### **City Hall Parking Lot**

**107 N Nevada Ave  
Downtown, CO 80903**

**Accessibility Evaluation**

SUBJECT: City Hall Parking Lot Self-Evaluation

### Finding: 2

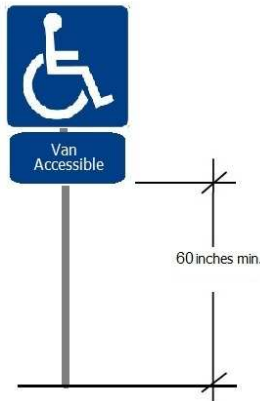
The required parking signage is mounted too low. In addition, the parking space is not designated as van accessible.

An accessible parking sign was installed, but is mounted at 54-1/2" to bottom of the sign.

Install a van accessible below the accessible parking sign at the space, and increase the height so the bottom of the lowest sign is between 5'-0" and 7'-0" above the bottom of the adjacent curb.
